The Sandstone Precinct: MOD 7 Design Report

Document Number
SP-RPT-E-MAKE-0005

MOD 7 Design Report

Roof

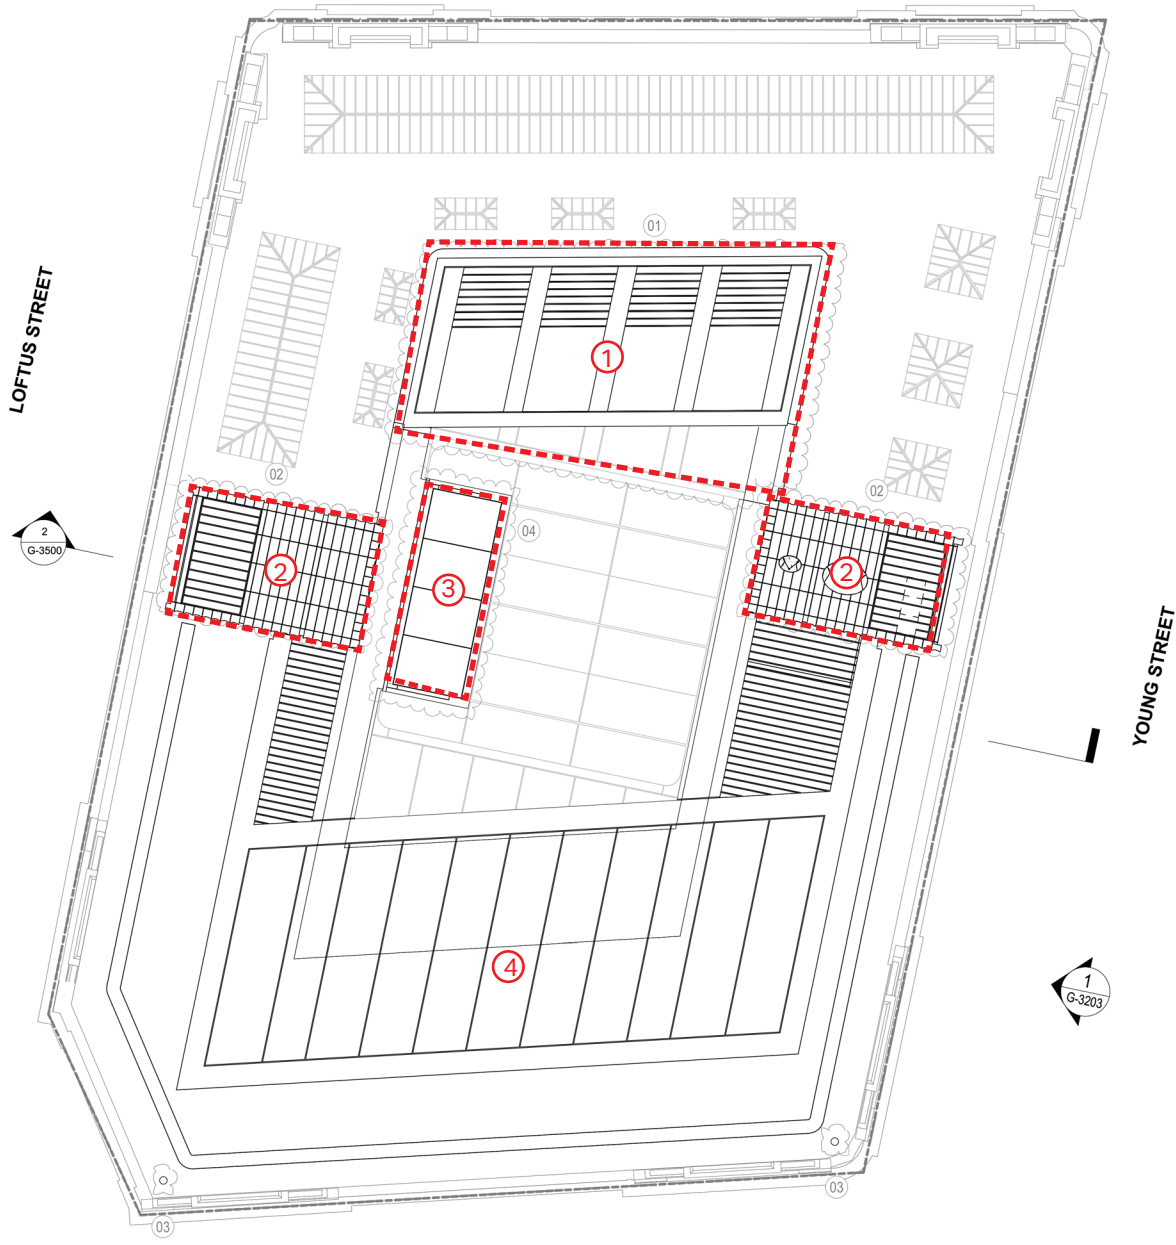
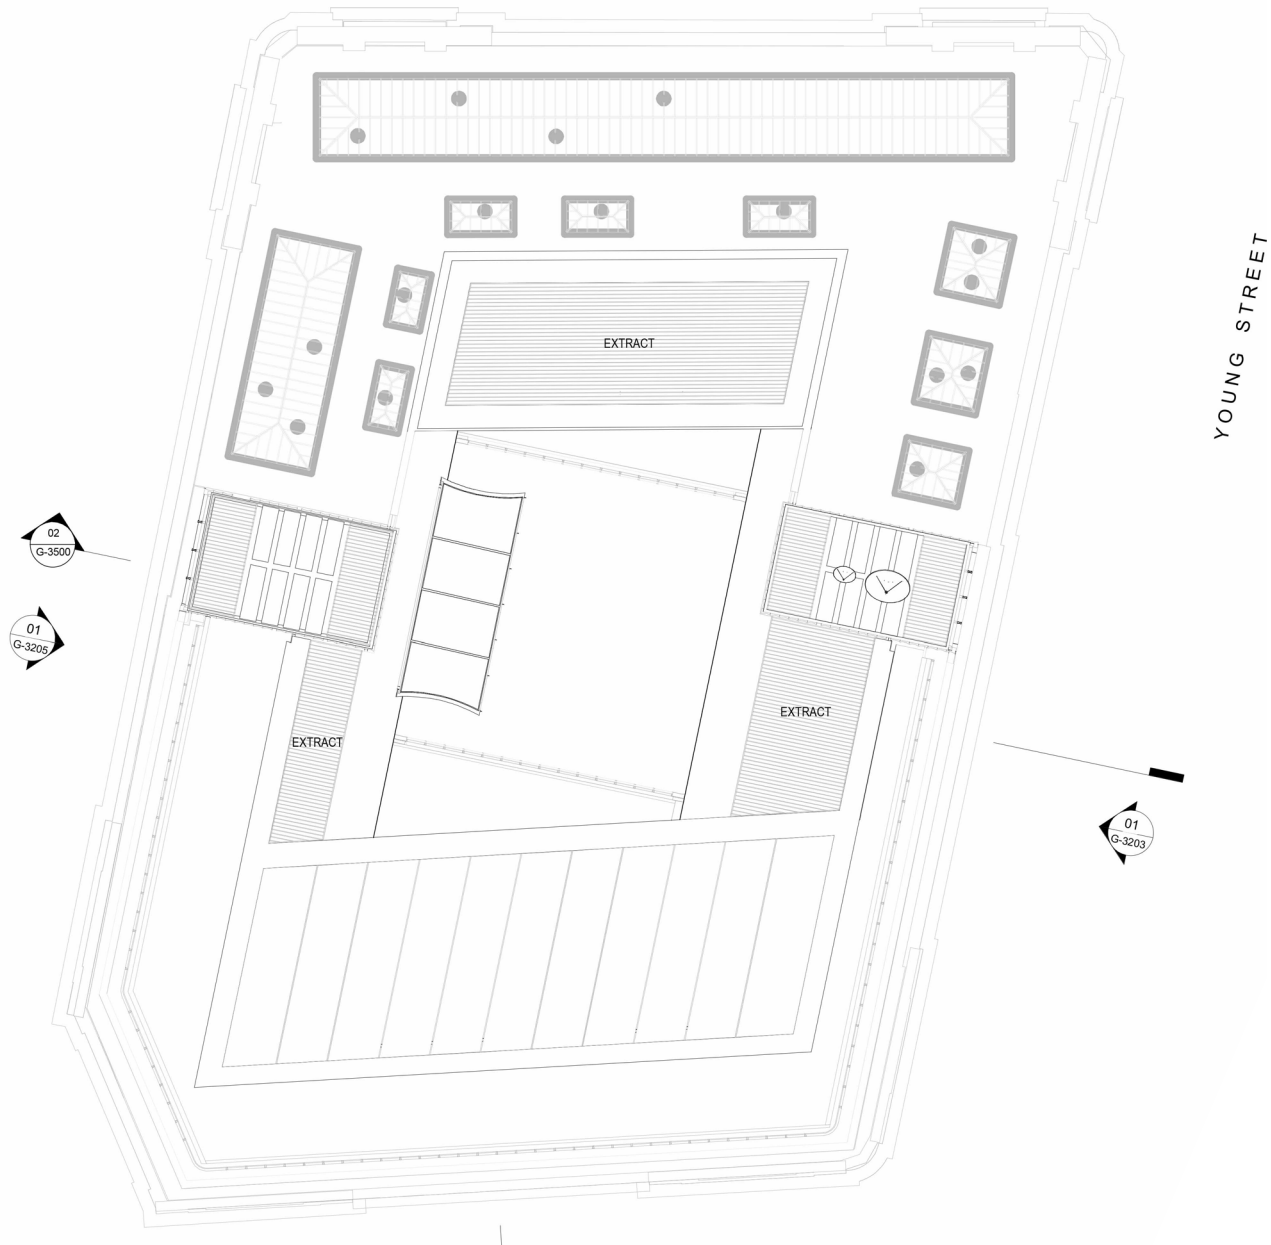
- Notes**
- 1. Cooling towers massing pushed towards the courtyard to allow for extra loading from the Lands Building. Roof articulation redesigned to accommodate for larger cooling towers and mechanical requirements.
 - 2. East and west tower roofs redesigned to accommodate for mechanical services and maintenance requirements
 - 3. Lift core roof adjusted to accommodate for the change in cladding on the facade
 - 4. Facade maintenance access balustrade added

Courtyard facade

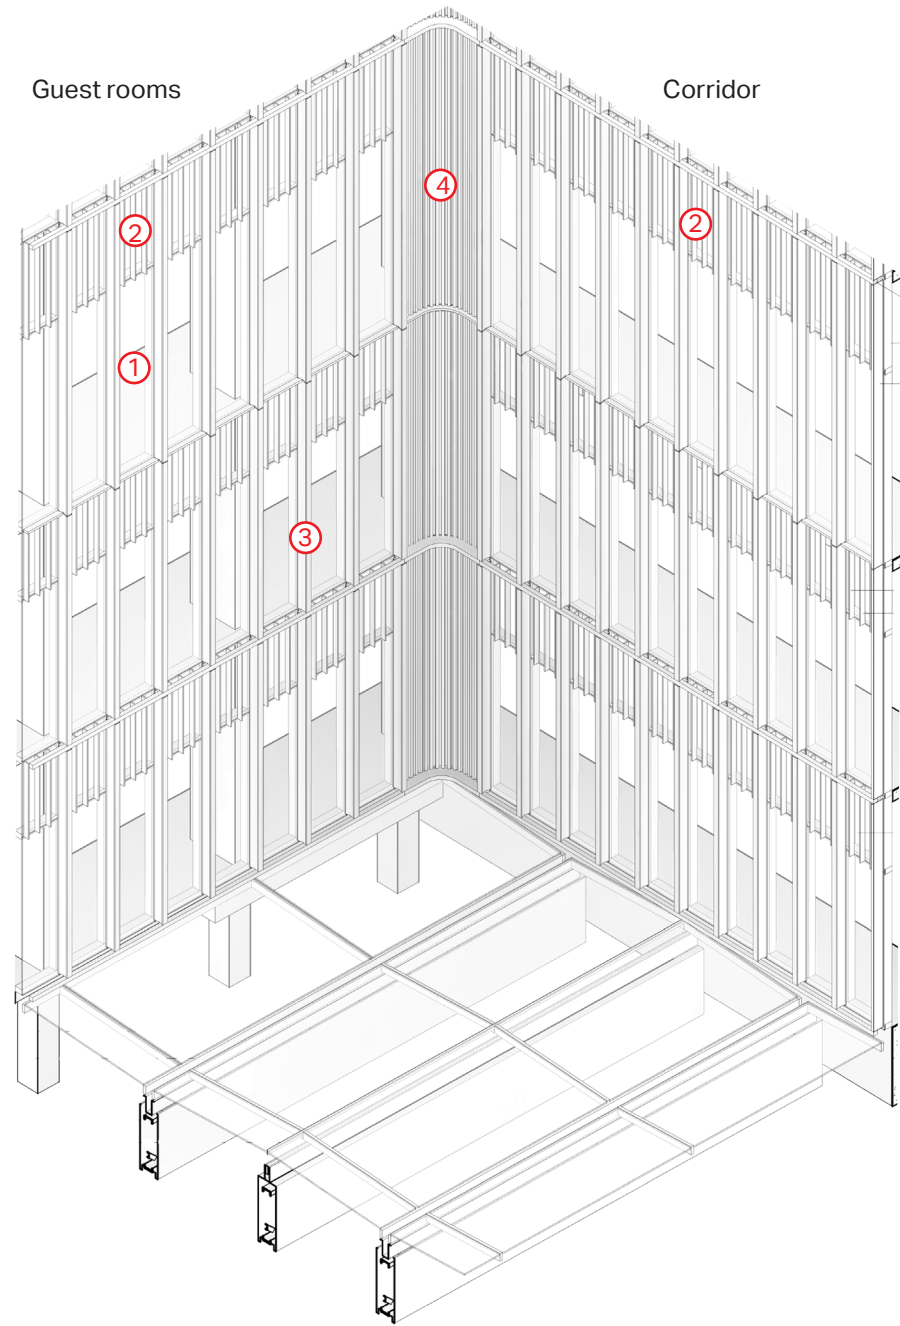
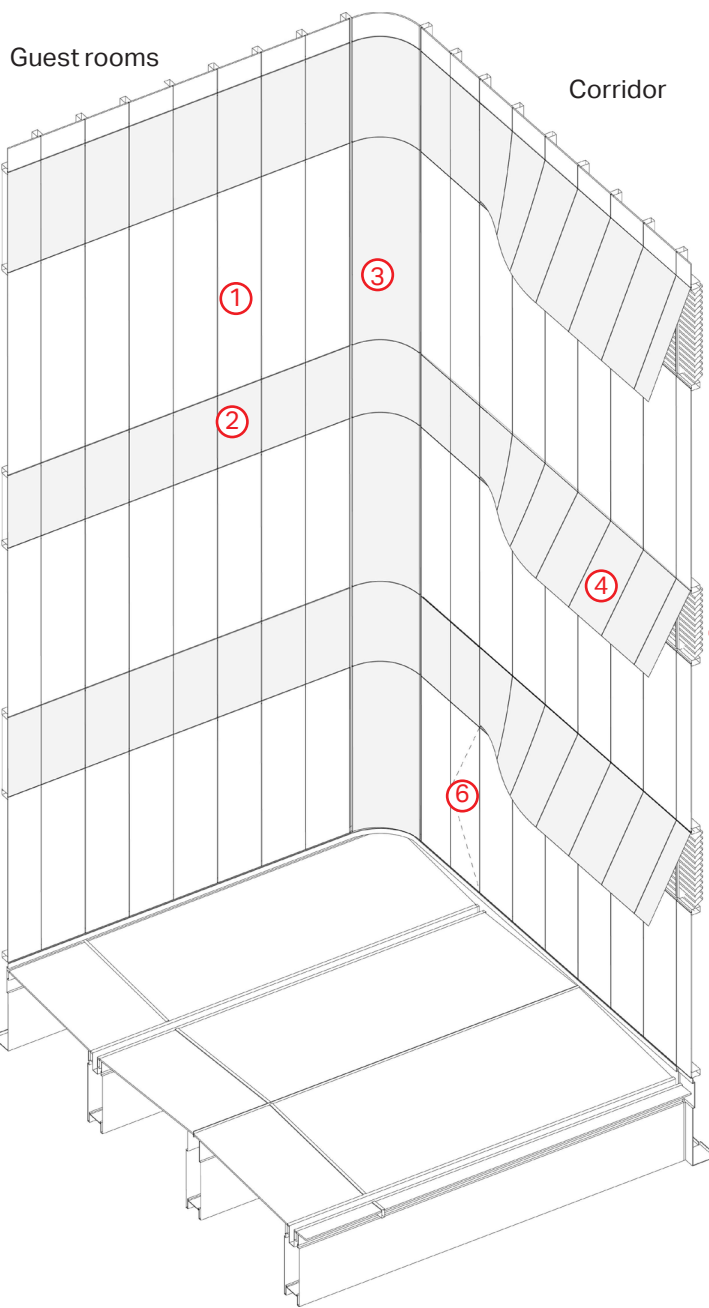
- 1. Full height glazing. PPC curtain walling to receive vertical and horizontal fins
- 2. Bespoke 'fish scale' air intake spandrels panel.
- 3. Anodised aluminium fluted vertical fins
- 4. Anodised aluminium ribbed, curved corners

We have further rationalised the facade whilst maintaining the privacy and a consistent aesthetic in the courtyard. The mullions are centred on the inter-tenancy walls between guest rooms.

- 1. Full height reflective glazing. PPC curtain walling
- 2. Reflective glazing spandrels with aluminium back-pan
- 3. Curved full height reflective glazing with aluminium back-pan
- 4. Double curved reflective spandrels panel to allow for mechanical ventilation
- 5. Mechanical louvres behind reflective spandrels. Dulux Monument PPC finish to match the curtain walling
- 6. Concealed door for maintenance access onto roof

Lift core cladding

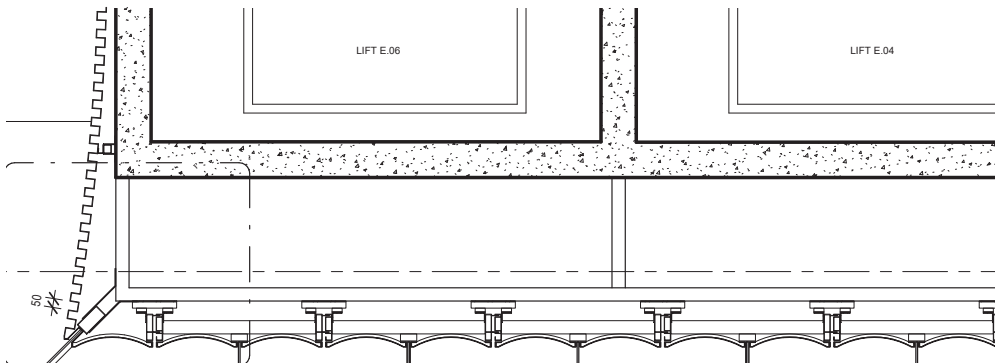
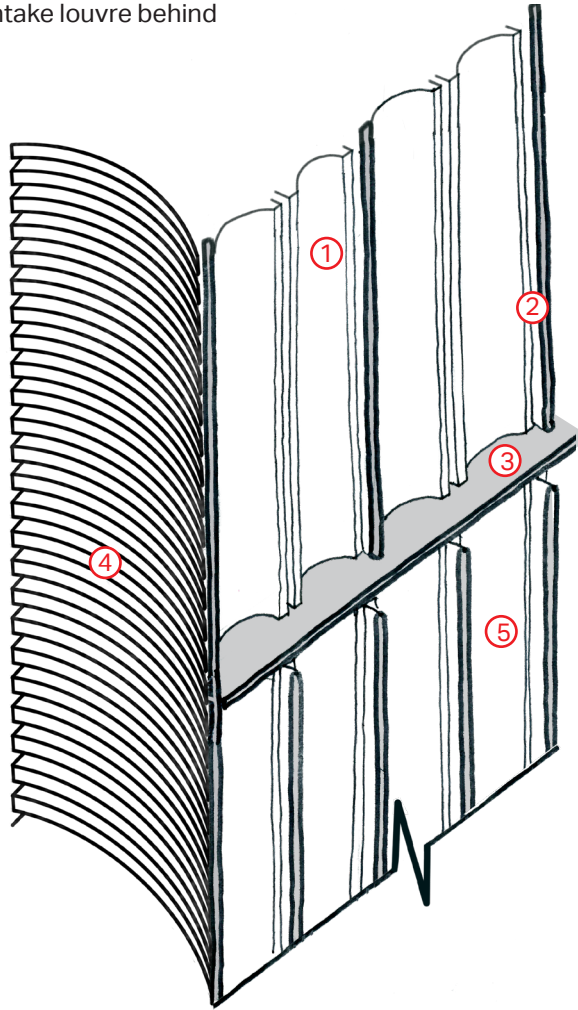
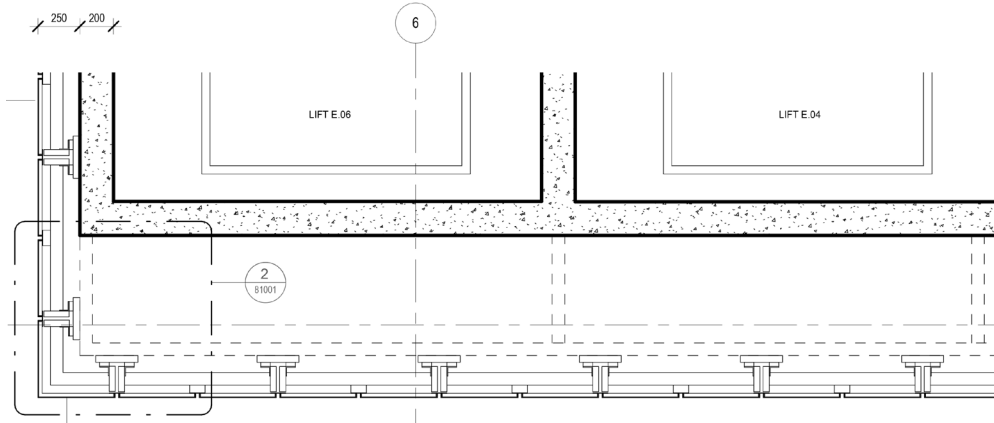
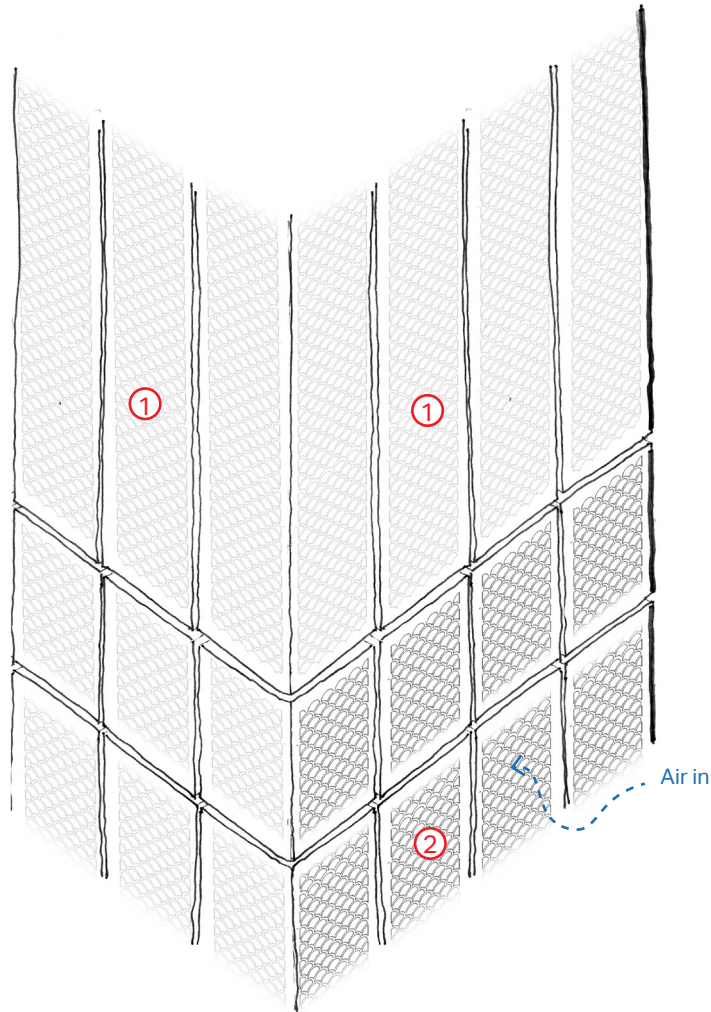
- 1. Fluted metal cladding system - champagne toned anodised aluminium finish.
- 2. Vertical fins - champagne toned anodised aluminium finish
- 3. Horizontal capping rails- champagne toned anodised aluminium finish
- 4. Curved and ribbed metal side panels
- 5. Perforated, fluted metal architectural louvre- champagne toned anodised aluminium finish. Weatherproof mechanical air intake louvre behind

- 1. Cassette metal cladding system - charcoal toned PPC finish. Pressed metal fish scale pattern to match air intake louvre below
- 2. Architectural louvre (fish scale pattern) - charcoal toned PPC finish with vermin mesh and weatherproof mechanical air intake louvre behind

Courtyard roof

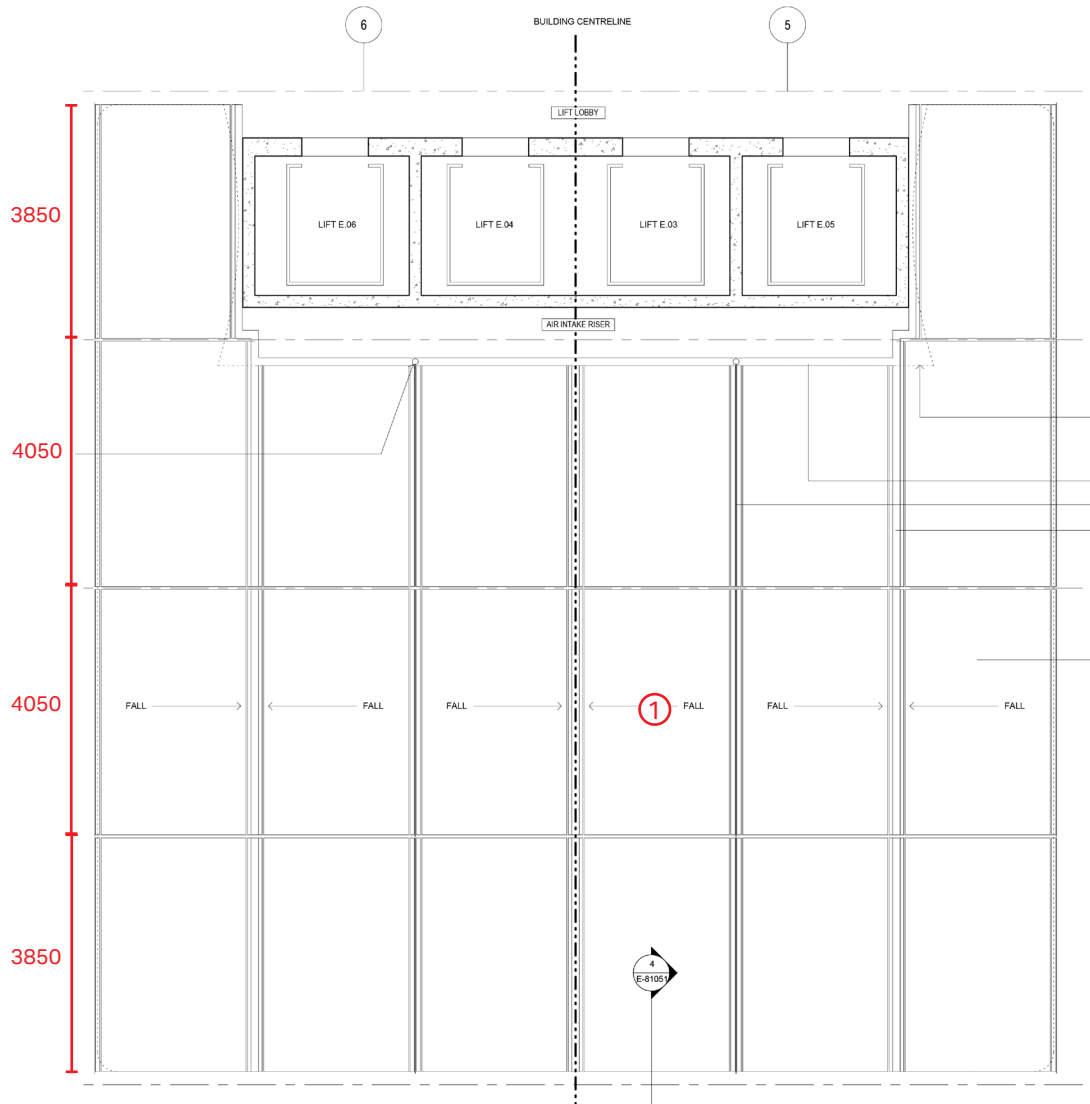
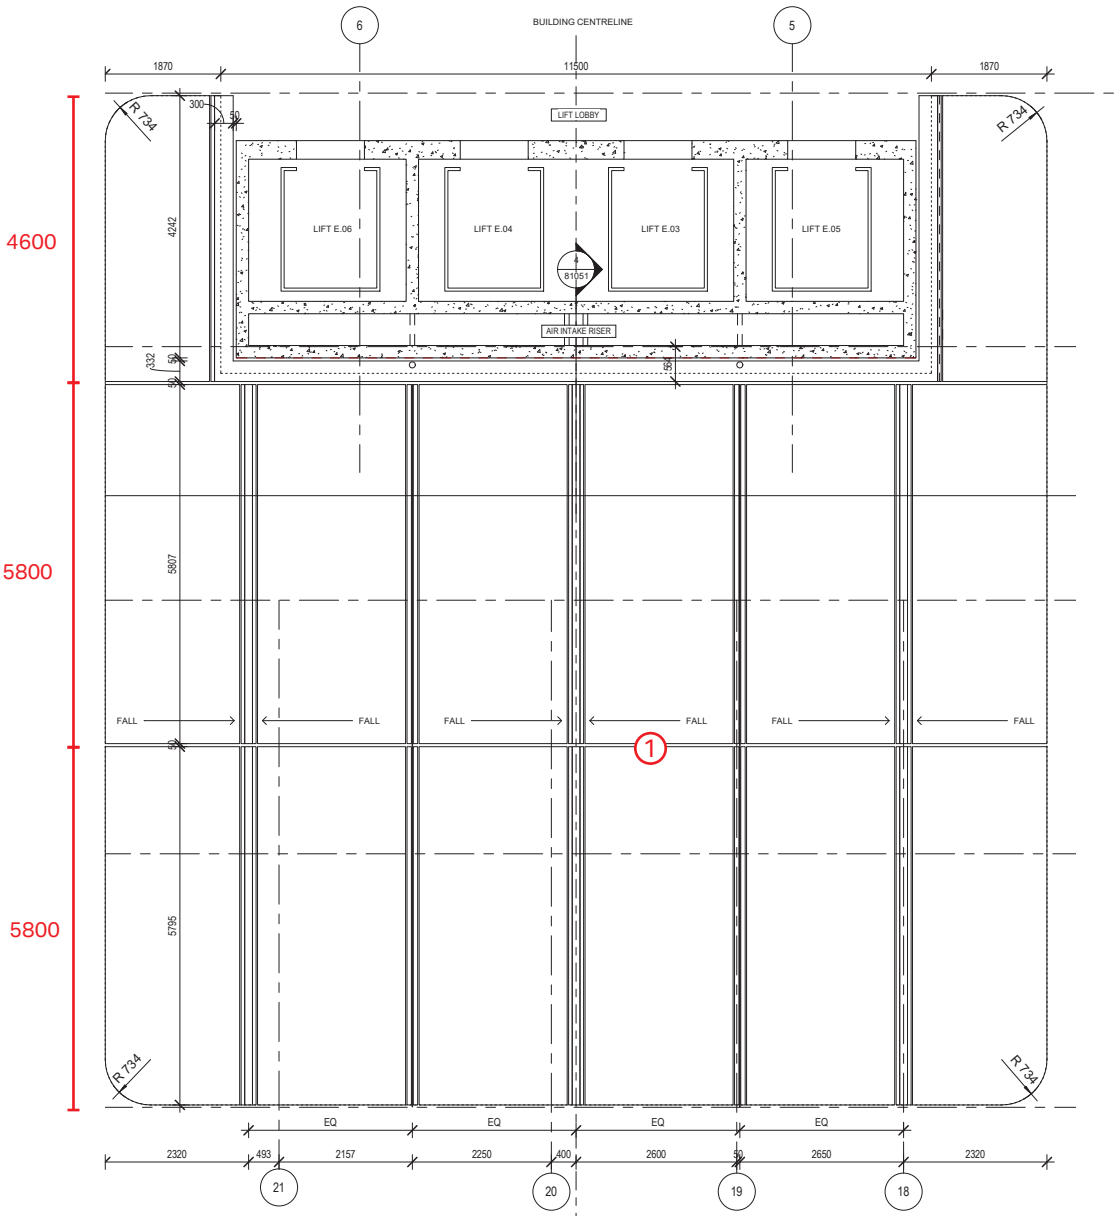
- 1. Large format, single laminate safety glazing
- 2. Metal clad, charcoal toned, beams with integrated stainless steel gutter

The setting out of courtyard roof glazing has been amended to align with the revised courtyard facade glazing.

- 1. Large format, single laminate safety glazing
- 2. Metal clad, charcoal toned, beams with integrated stainless steel gutter
